Appeal of Board of Zoning Appeals Decisions Related to

United Village

Restaurant Pavilions

**Zoning File: #24-033509 (Appeal of Zoning file #24-023545)
1566 University Ave W (Temporary Address)**

F1 A - North Elevation

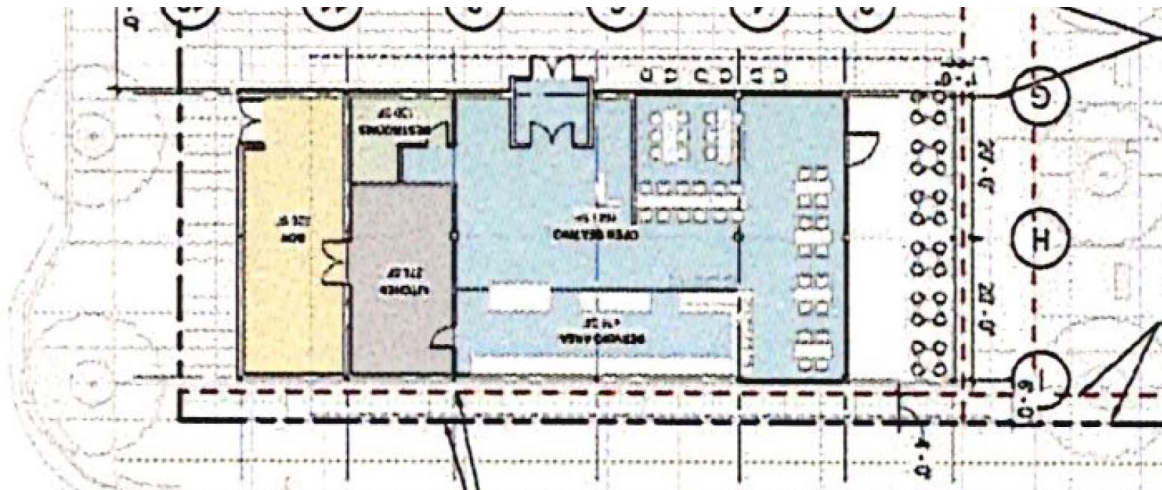
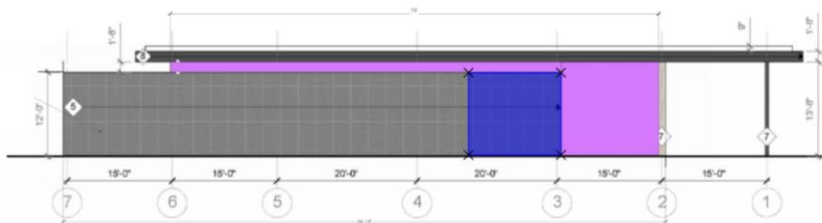
- Northern Façade: 19.6%, 10.4% variance

Dark blue box is about 153 square feet. (Size of shortage.)

3. There are opportunities to increase the window percentage to meet the requirement on the northern façade, given that the uses along the northern façade are primarily the dining room and serving area. **This finding is not met for the 19.6% request for the northern façade.**

4. The request for a variance of the window and door percentage on the northern façade seems to be self-created, as the zoning code does not prohibit windows in serving areas. **This finding is not met for the 19.6% request for the northern façade.**

BZA denied the northern façade variance request (19.6% proposed) based upon finding 3 & 4.

View from Spruce Tree

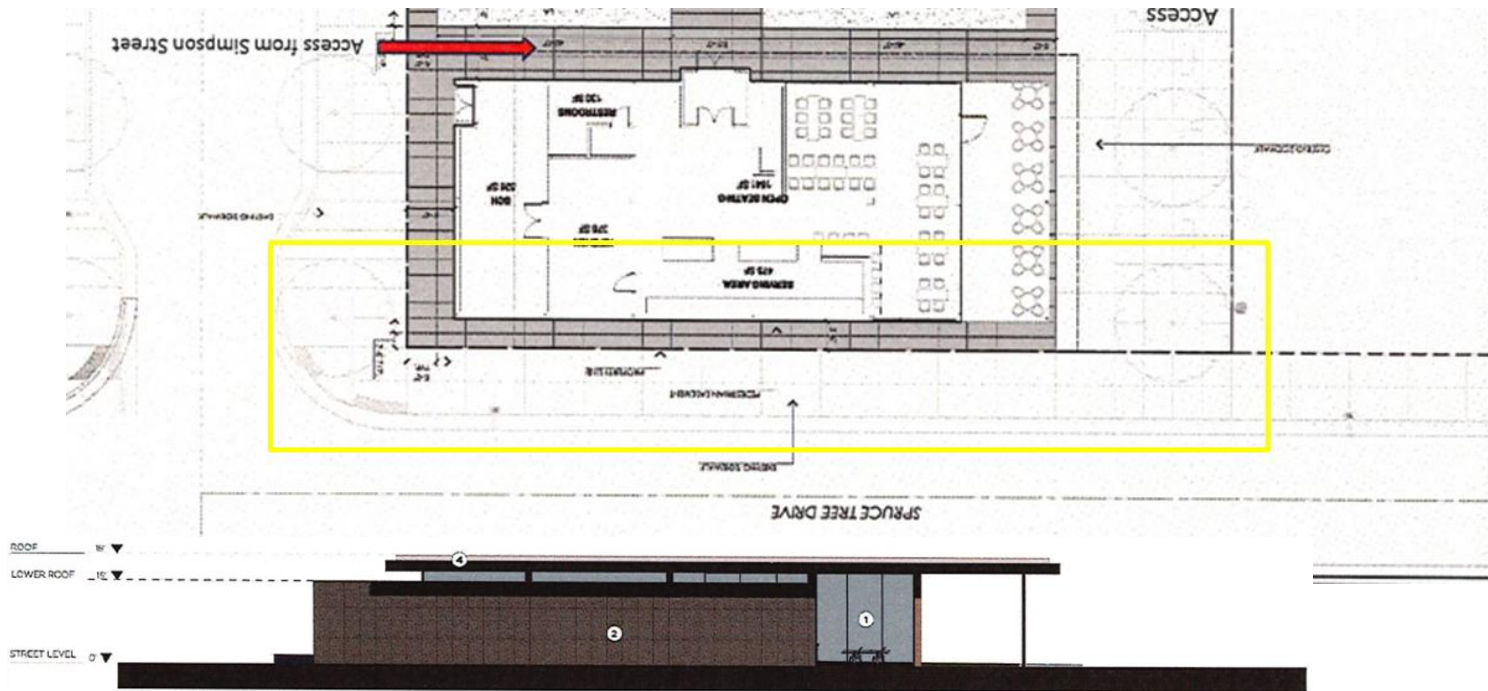
3. All new buildings within the master plan boundary must have a primary pedestrian entrance on arterial, collector, and/or local streets.

3. Staff believe that it is possible to add a primary pedestrian entrance on the northern façade of the northern restaurant building, similar to the door on the southern entrance of the southern building into the dining room. Staff do not believe that there are practical difficulties in complying with the provision for this request. **This finding is not met for the request to omit a primary pedestrian entrance along Spruce Tree Avenue.**

4. Staff believe that the plight is self-created for the primary pedestrian entrance along Spruce Tree Avenue, as the dining room abuts this side of the building, where an entrance could be included. **This finding was not met for omission of a northern primary pedestrian entrance along Spruce Tree Avenue.**

BZA denied request to omit a primary pedestrian entrance on the northern façade based upon finding 3 & 4.

F1 A - North Elevation

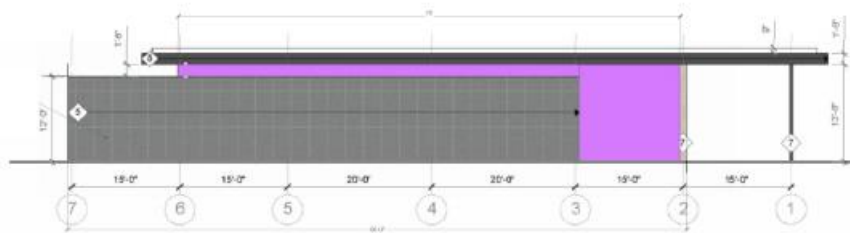
North Building North Facade

proportion glazed 19.6%

439 Required
153 Shortfall
